2.0 SITE CHARACTERISTICS

This chapter of the North Anna 3 combined license (COL) Final Safety Analysis Report (FSAR) addresses the geological, seismological, hydrological, and meteorological characteristics of the site and vicinity, in conjunction with present and projected population distributions and land use and site activities and controls

Section 2.0 of the North Anna 3 COL FSAR incorporates by reference Section 2.0 of the Economic Simplified Boiling-Water Reactor (ESBWR) design certification document (DCD), Revision 5. In addition, FSAR Section 2.0 incorporates by reference ESP-003 for the North Anna ESP Site, issued pursuant to 10 CFR 52.24, and documents related thereto (e.g., North Anna ESP Application Site Safety Analysis Report (SSAR), Revision 9).

Figure 2.4.2.4-101 Site layout and sub-basin drainage areas

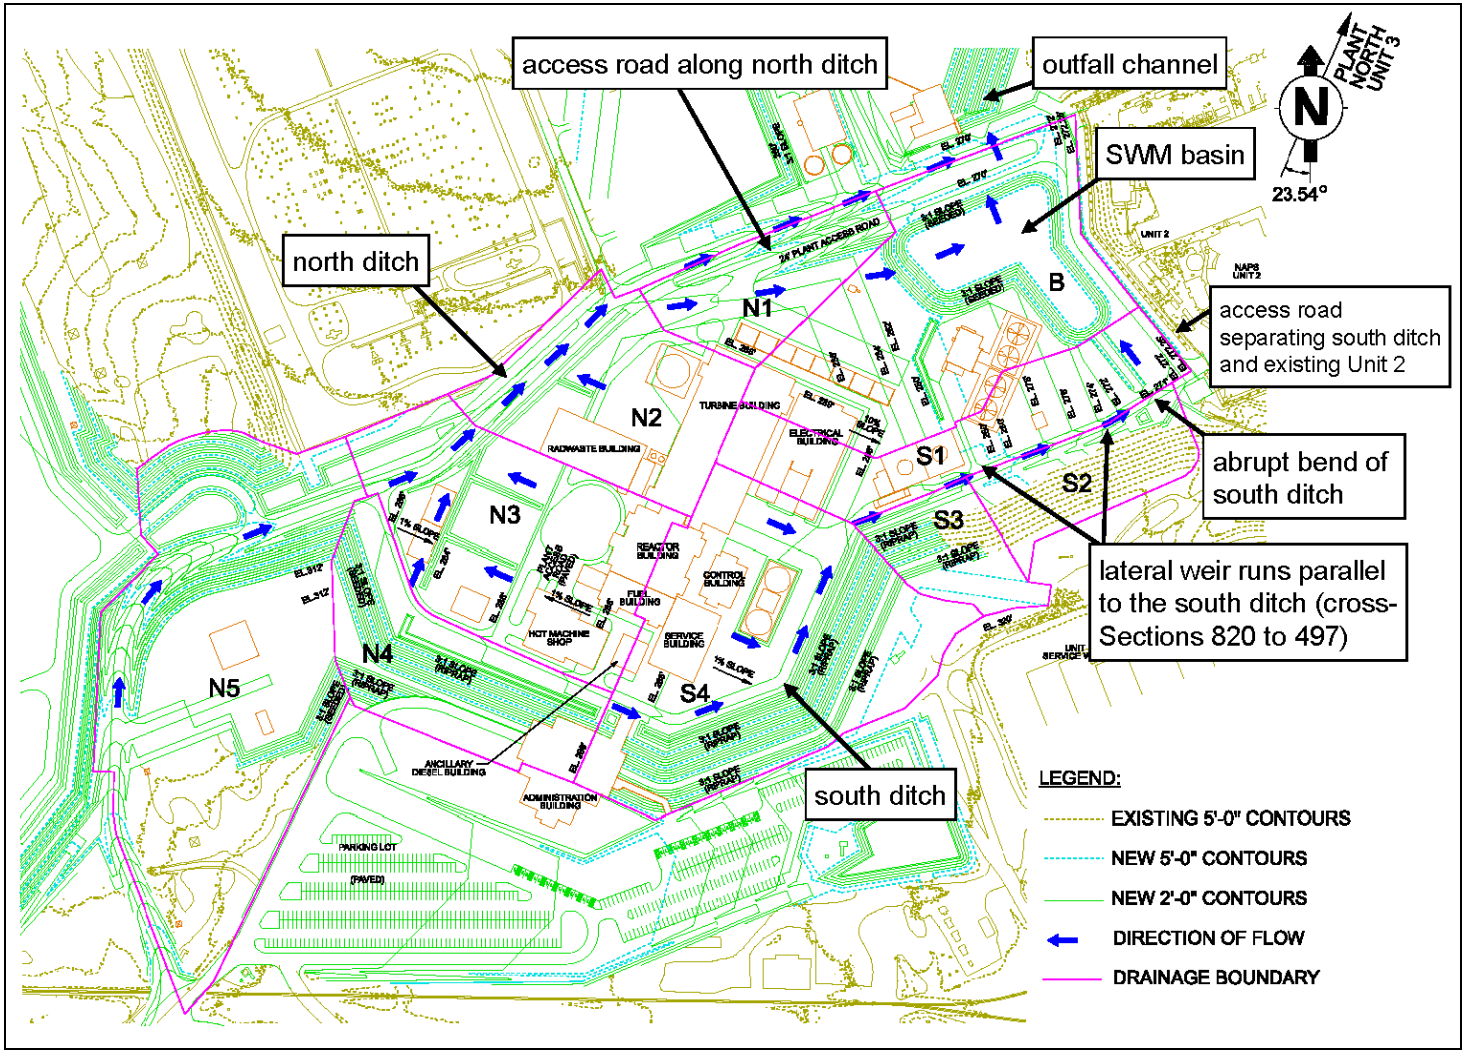
Information Submitted by Applicant The site drainage plan consists of two drainage channels (labeled north ditch and south ditch in Figure 2.4.2.4-101), a storm water management (SWM) Basin, and an outfall channel. The plant access roads were treated as broad-crested weirs. The applicant set up the hydraulic model (HEC-RAS) using Manning's n values of 0.030 for the grass-lined section and 0.035 for rip-rap lined sections. These values imply that the ditch is clean and straight with no deep pools but with some stones and weeds (HEC, 2008). The applicant used contraction and expansion coefficients of contraction = 0.1 and expansion = 0.3, which assume a gradual transition between two cross sections. However, for cross sections near the abrupt bend of the south ditch, near cross section 404, the contraction and expansion coefficient values were set to contraction = 0.3 and expansion = 0.5. These higher coefficient values were also applied at other abruptly varied sections, such as at the access road crossings of the north ditch (e.g., cross sections 1312 to 1190 and 550 to 288). The downstream boundary condition of the HEC-RAS model is the water surface elevation of Lake Anna applied at cross section 0. The applicant assigned a constant elevation of 265 feet.

A lateral weir structure along the south ditch provides overflow relief for cross sections 820 through 497 (see Figure 2.4.2.4-101). The applicant's simulation results indicate this structure conveyed approximately 139 cubic feet per second (cfs), with approximately 300 cfs remaining in the south ditch at the abrupt bend near cross-section 380. To evaluate the sensitivity of water surface elevations near this abrupt bend, the staff removed the lateral weir from the HEC-RAS input so that the south ditch conveyed the entire 439.1 cfs. The resulting water surface elevation at cross-section 380 increased to 272.24 feet, or 0.01 foot below the access road crest between the south ditch and the Unit 1 and 2 yard (see Table 2.4.2.4-101).

Figure 2.4.2.4-102 Site layout and HEC-RAS cross section locations

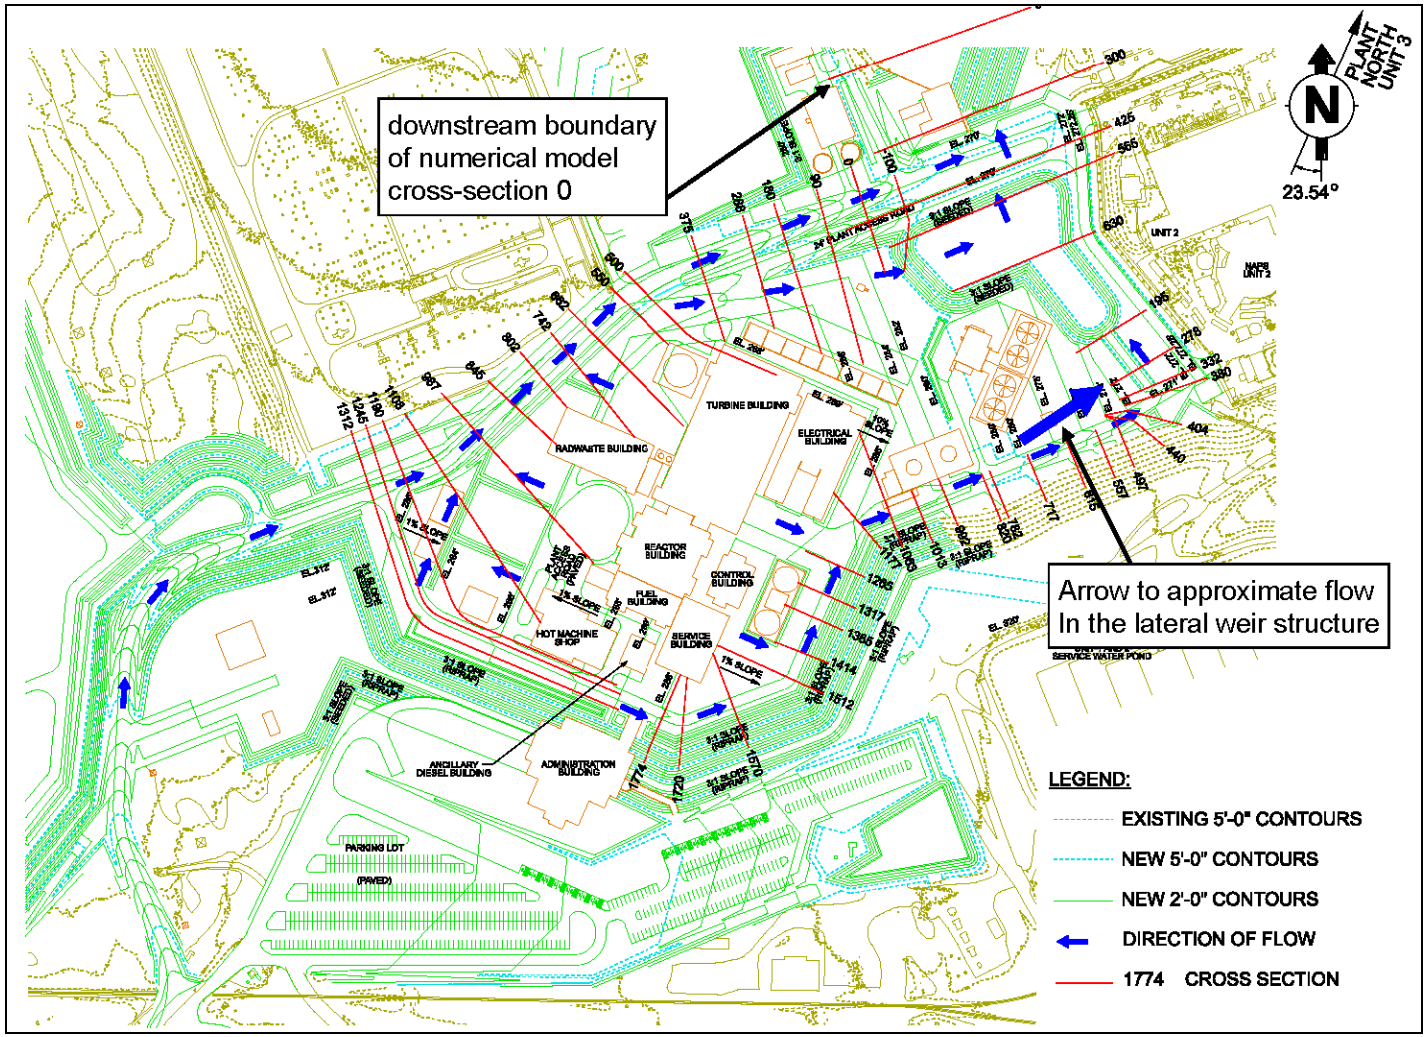
Staff performed a second sensitivity test of the lateral weir structure by altering the location where the weir flow reentered the south ditch (see Figure 2.4.2.4-102). The applicant's simulation specified that this flow would reenter the south ditch at cross section 278. The staff's simulation assumed that the flow ran parallel to the south ditch and reentered between cross sections 404 and 380. The resulting water-surface elevation at cross-section 380 was 272.24 feet, or 0.01 foot below the access road crest between the south ditch and the Unit 1 and 2 yard. These results are nearly identical to the first sensitivity test where the lateral weir was completely removed and all flow was confined to the south ditch (see Table 2.4.2.4-101).

Figure 2.5.4-1 Typical Subsurface Profile across Unit 3 Power Block Area (FSAR Figure 2.5-215)

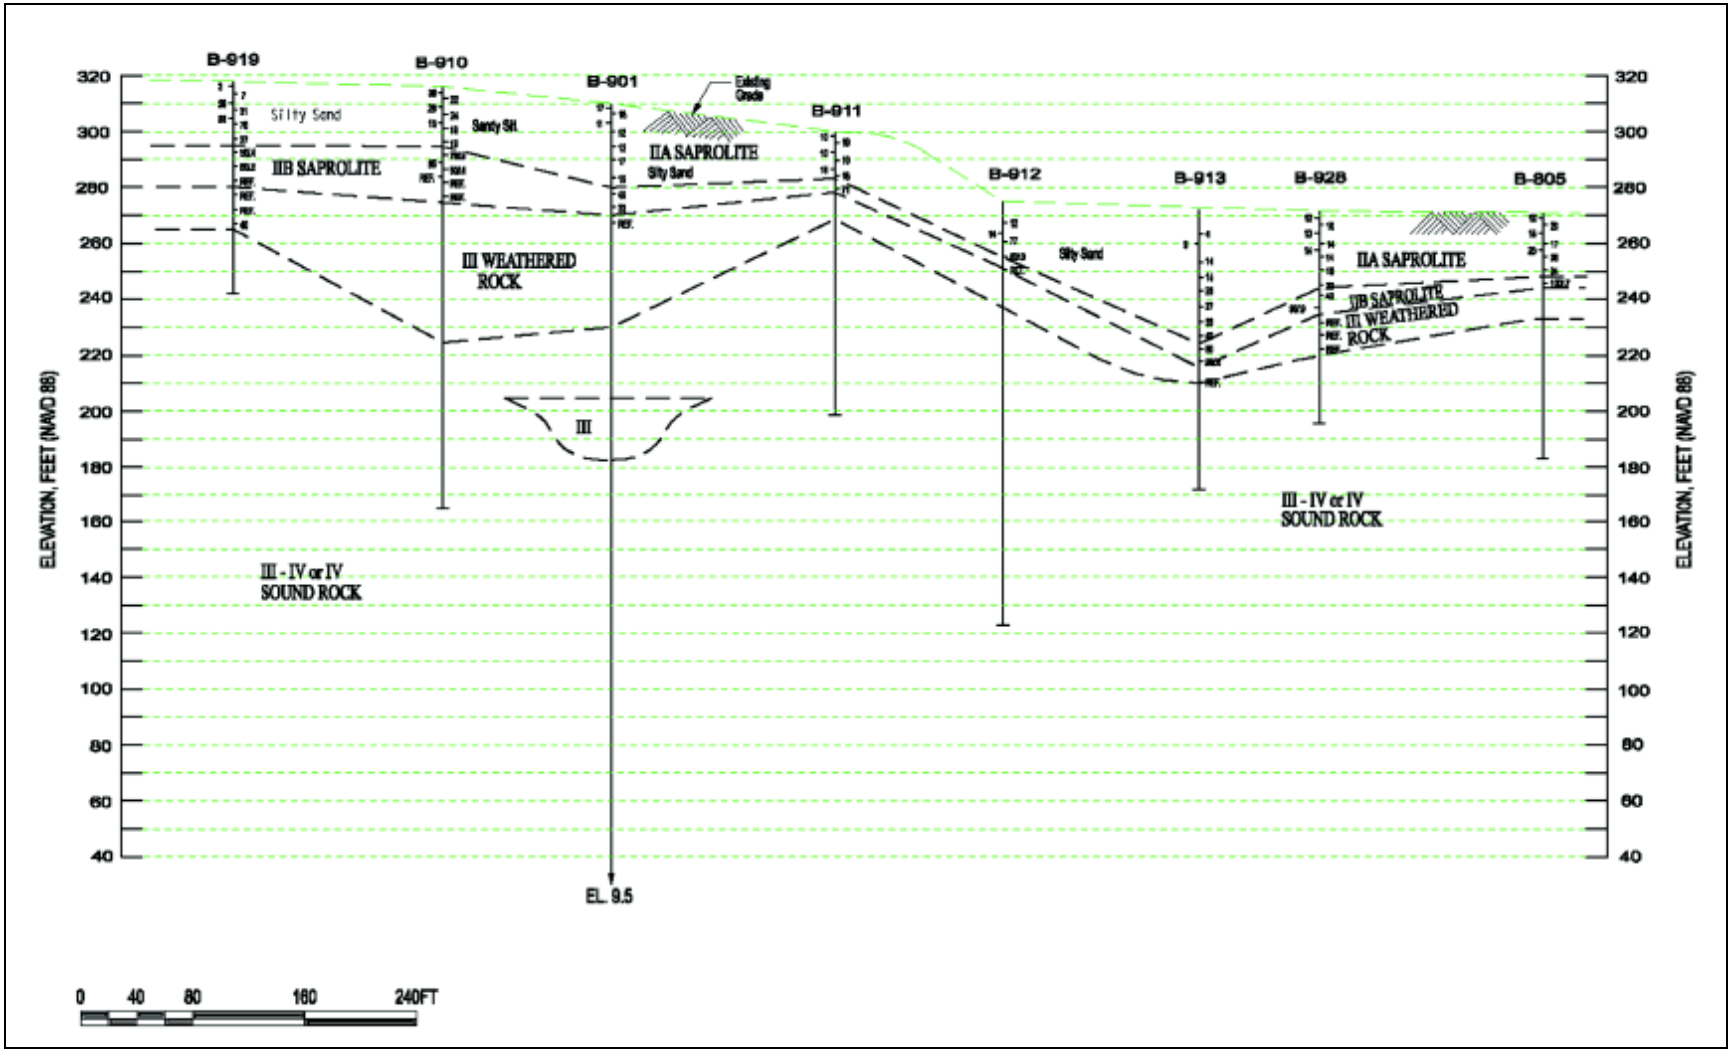
materials at the Unit 3 site. The staff reviewed the applicant's description of the four zones of subsurface rock and the methods used to determine the engineering properties and to develop the subsurface profile (see SER Figure 2.5.4-1). The applicant utilized multiple field and laboratory investigations including boring sample analysis, observation wells, and CPTs. The staff also reviewed the applicant's use of the latest field and laboratory methods, in accordance with RGs 1.132 and 1.138, to determine the properties of the subsurface materials. The staff determined that the information is acceptable because the applicant had followed the guidelines of RGs 1.132 and 1.138.

Figure 2.5.4-5 Unit 3 Boring Locations (FSAR Figure 2.5-221)

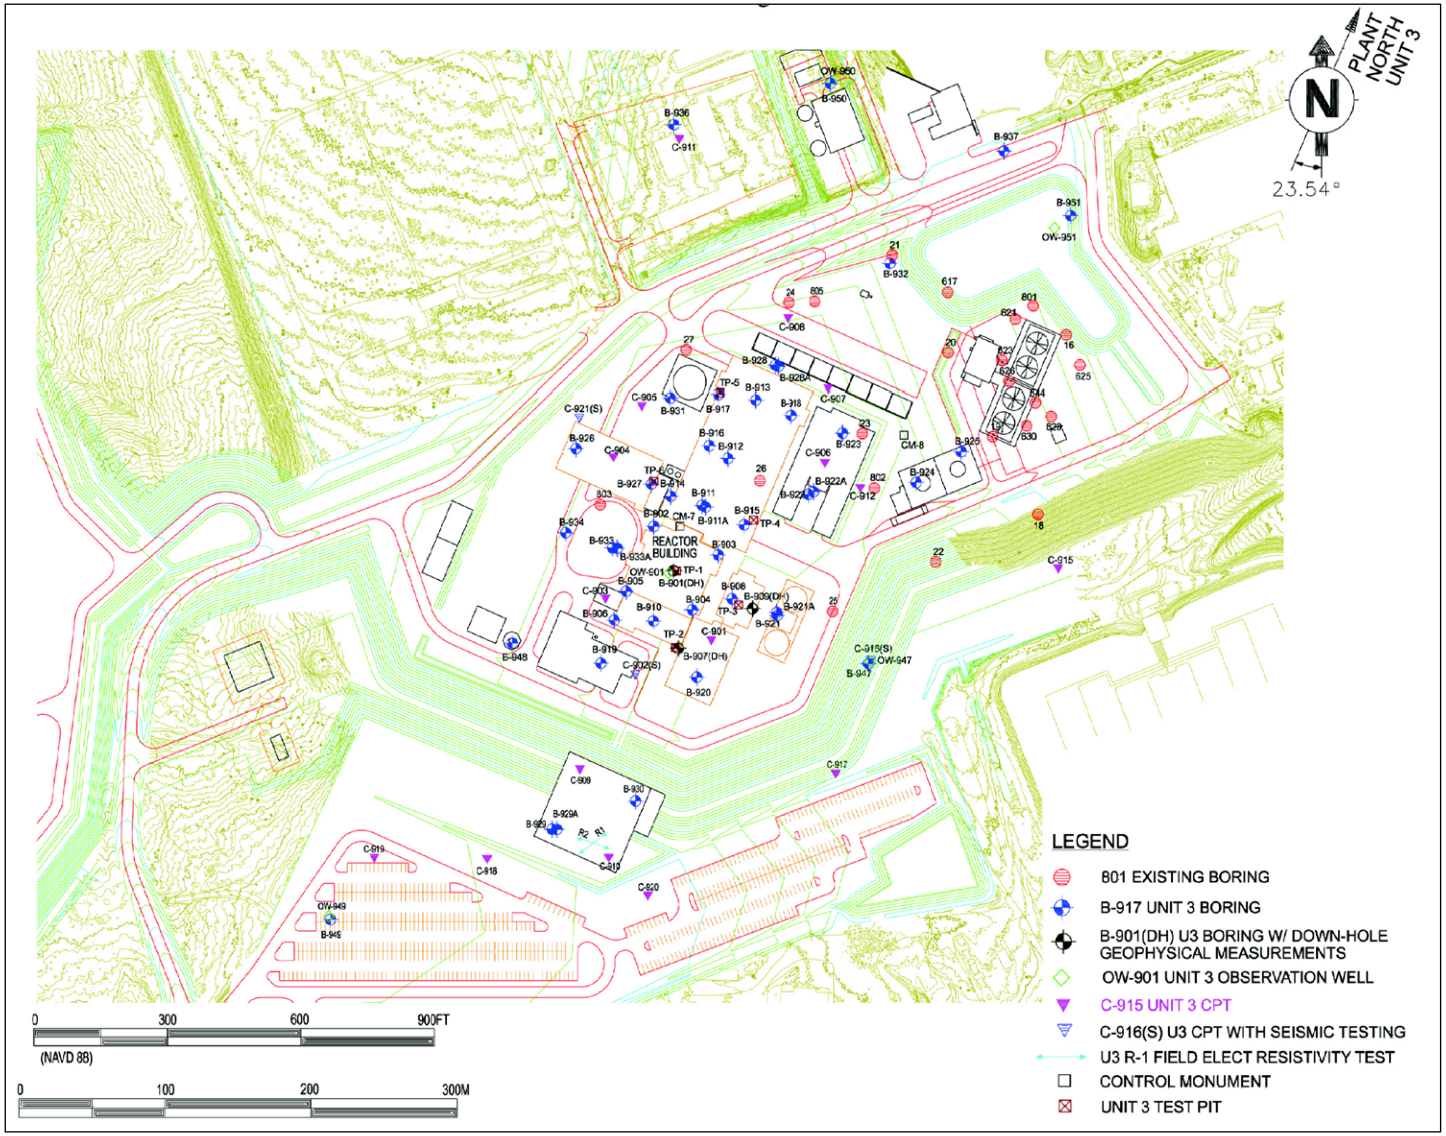
The staff reviewed the additional borings performed by the applicant to confirm engineering properties and the stability of soil and rock underlying future plant structures, systems, and components. As part of this review, the staff also examined the site exploration points for the Unit 3 subsurface investigations, including FSAR Figure 2.5-221 (see Figure 2.5.4-5 of this SER), which shows the locations of additional boreholes, observation wells, CPTs, electrical

concluded that the additional boreholes are sufficient to resolve DCD COL Item 2.0-29-A, which requires the COL applicant to complete additional borings at the COL site to address the provisions listed in ESBWR DCD Table 2.0-1, regarding stability of subsurface material and foundation requirements.

Figure 2.5.4-6 Excavation and Backfill Plan for Cross Section A-A' (FSAR Figure 2.5-229)

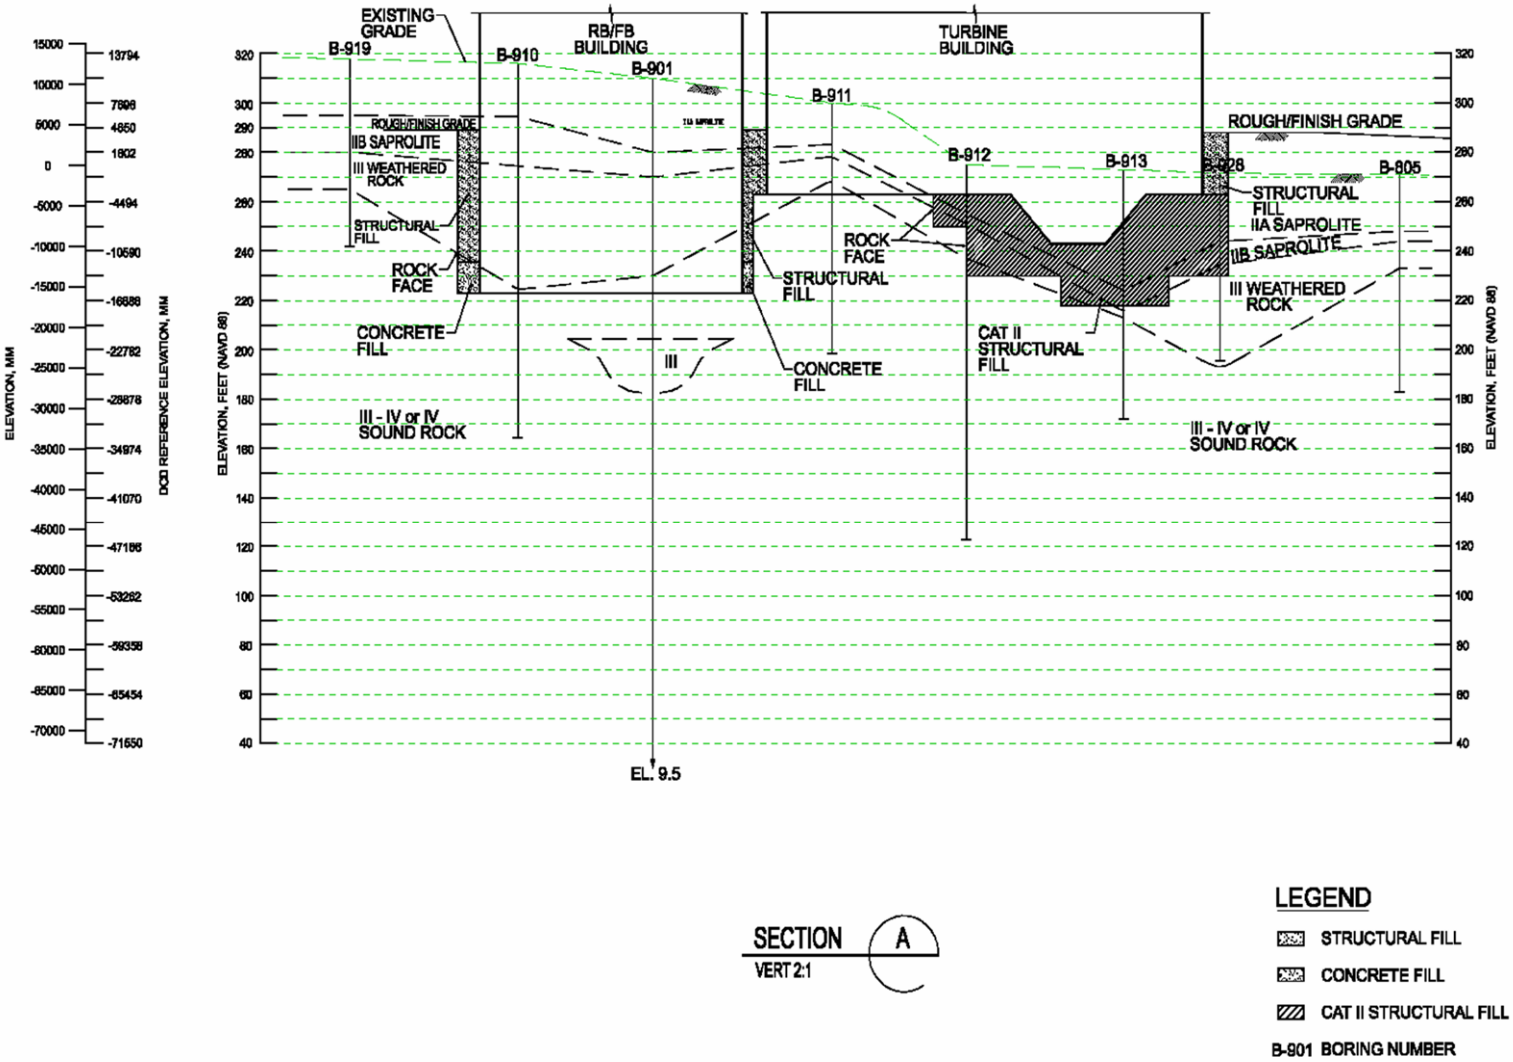
Finally, the staff reviewed the future excavation and backfill plans for the Unit 3 site. This review included the applicant's excavation and backfill plans as presented in FSAR Figures 2.5-214 and 2.5-229 through 2.5-234 (see Figure 2.5.4-6 of this SER for an example). The staff concluded that the information illustrated in these figures, together with the description in FSAR Section 2.5.4.3, meets the minimum acceptability requirements of 10 CFR Parts 50 and 100.

ESP COL Action Item 2.5-3 requires the applicant referencing the North Anna ESP to provide detailed excavation and backfill plans for the Unit 3 site. In FSAR Section 2.5.4.3, the applicant provided the plot plans and comparison figures of the excavation, subsurface profiles, and safety-related foundations. The plot plans and excavation and backfill plans were presented in FSAR Figure 2.5-229, reproduced as SER Figure 2.5.4-6. In FSAR Section 2.5.4.5.3, the applicant described the backfill sources, compaction, and quality control measured to be implemented during the period of excavation and backfilling. The applicant included necessary details such as the source and type of backfill, the extent of excavations, and the compaction specifications that the backfill will be designed to meet. The applicant also described the quality control measures that will be employed to ensure the backfill met the design values. The staff concluded that the applicant has provided adequate information to describe the excavation and backfill plans for the Unit 3 site as required by ESP COL Action Item 2.5-3. Accordingly, the staff considers ESP COL Action Item 2.5-3 to be resolved.
